General Information		
Project Name and Location	Eagle Ranch MVD  9651 Fuel Rance	ch	
Site Contact Name & Agency	9651 Eugh Rance E Lance Signon Eagle Visto LLC	ESC File No	
Date of Inspection	4-18-18	Start/End Time	9135/ 9144
Inspector Name, COA Dept.	Curtis Cherne, St	ormwater Qu	ality /
Describe Present Phase of Construction	Stablized		
Type of Inspection:  Regular During stor	rm event • Post-storm event (> 0.5 inch) • 3	11 / Complain	t Response • Follow-Up
	Weather Information		
Weather at time of this inspecti		Windy	Temperature: ~F°
Has there been a storm eventsi  Amount: • < 1/4" • (1/4" to 3)			
	Erosion & Sediment Control Inspec	ction	
Entrance / Track-Out	JUN		
Sediment Controls / Silt Fence, Inlet Protection, Wattles, etc.	540611210		
Inspection Reports			
Erosion Controls Housekeeping/Pollutant Contr	ols		
Debris/Pollutants/Sediment in Notes	MS4		
Is site being maintained in complian	nce with the Drainage Ordinance ? * Yes * No	Cut a	Mene 4-18-18 Date

Site: Eagle Ranch MVD

## **Re:** Drainage Ordinance (14-5-2-1) Violations for Erosion and Sediment Control and Trash

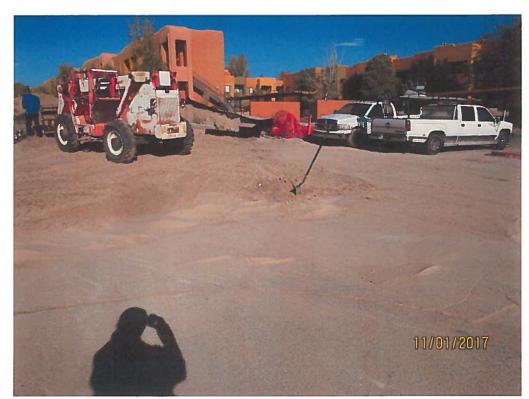
- 1. No stabilized construction entrance (track-out pad).
- 2. No BMP for opening into the storm drain system.
- 3. Concrete wash-out and acceptable wash-out facility was not observed onsite.
- 4. Disturbed area in the northwest corner without a sediment BMP.
- 5. No sediment BMP at asphalt interface.

Disturbed area in northwest corner without a sediment BMP.

- 3. Remove all instances of concrete wash-out and bring-in or install an acceptable wash-out facility was not observed onsite.
- 4. Provide a sediment BMP or stabilize the disturbed area in the northwest corner of the site.
- 5. Provide a sediment BMP at the asphalt interface.

No sediment BMP at asphalt interface.

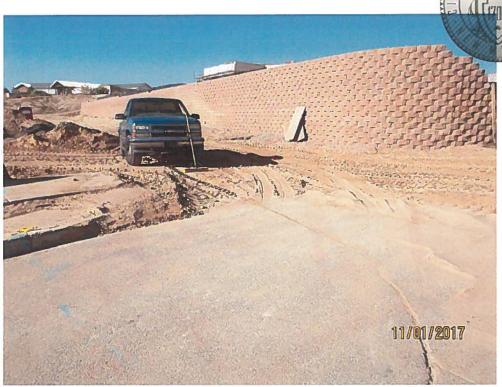
No sediment BMP at asphalt interface.

No BMP along northern edge of the site.

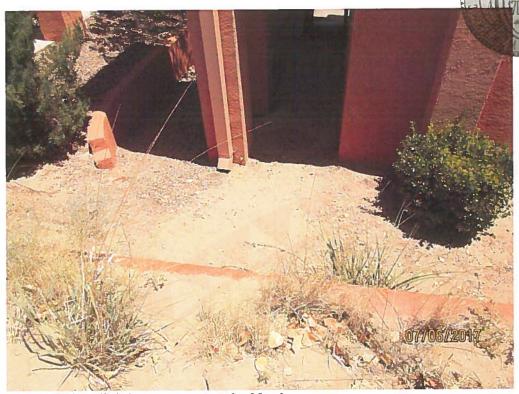
- 1. No BMP to prevent windblown sediment from leaving the site along the northern edge of the site.
  - 2. Windblown sediment in adjoining property to the north.
  - 3. Trash not in a trash receptacle and trash receptacle not observed onsite.
  - 4. No track-out pad/stabilized construction entrance.
  - 5. No sediment BMP to prevent sediment from leaving the site at the cul-de-sac.

1. Install a sediment BMP to prevent sediment from leaving the site along the northern edge of the site as shown on the approved ESC plan.
